THE GLIDING FEDERATION OF AUSTRALIA

GFA AN 56
(ISSUE 6)

AIRWORTHINESS ADVICE NOTICE

SUBJECT: Miscellaneous airworthiness information.

FIGURE 1 RELEASE CUT OUT

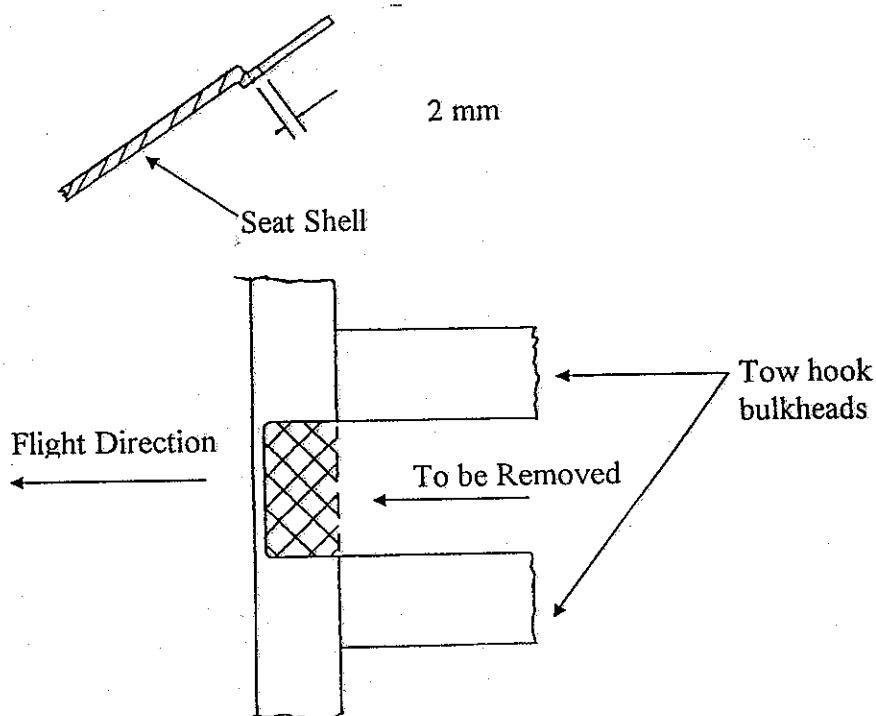
1. *SIMPLIFIED CG RELEASE REMOVAL.* The relatively small access hole for the belly release makes removal of the release at each annual inspection difficult. The cut out in the seat shell can be enlarged in accordance with Figure 1 to make removal of the release easier.

FIGURE 2. EXPANDED FUSELAGE SKINS

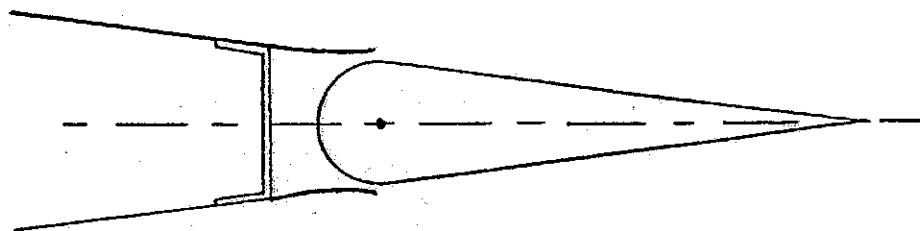
The gap between the fin and the rudder may be enlarged. This changes the airflow around the rudder and may excite flutter. The gap may be closed by heating the FRP (contact DG for times and temperatures) or the gap may be sealed using vee tapes. (see Figure 2 and Figure 3)

FIGURE 4. SIDE VIEW OF RUDDER

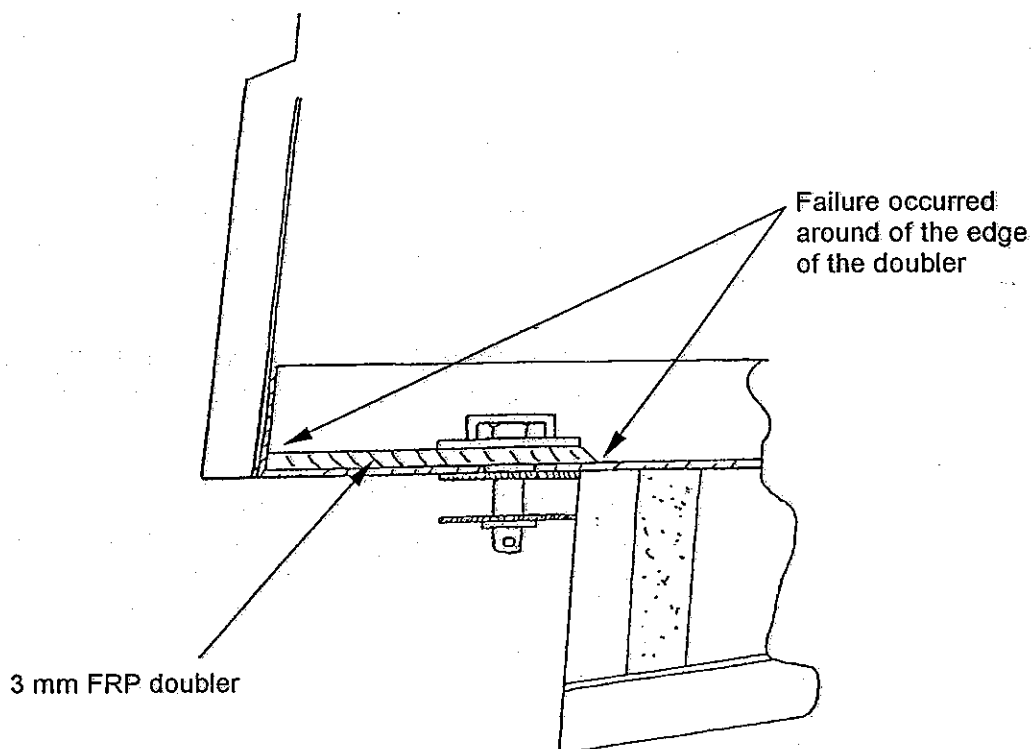
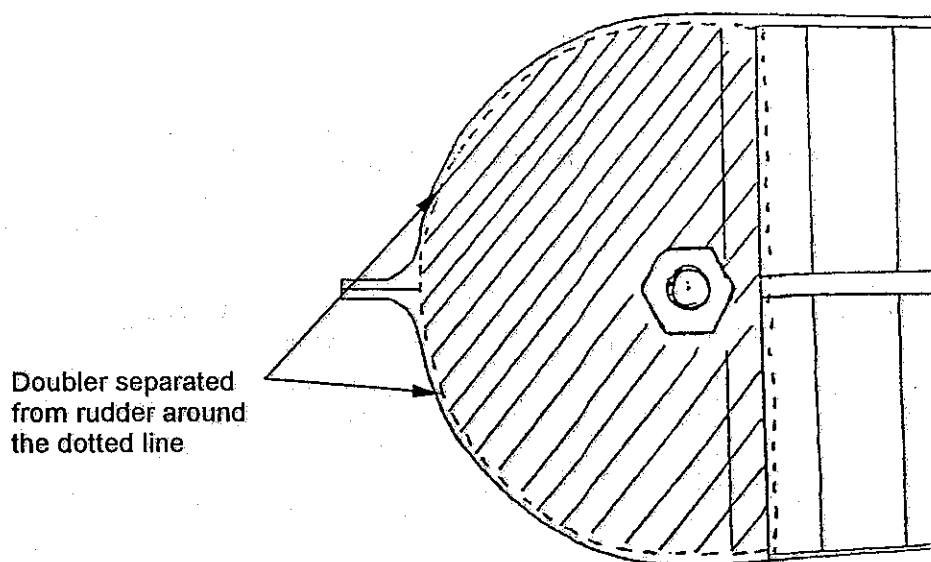
3. *RUDDER FAILURE.* There has been one reported case of a DG-200 rudder failing in flight. The failure may have resulted from prior damage in a ground loop or heavy landing therefore it is recommended that this area be closely inspected at each annual inspection and after any heavy landings or ground loops.
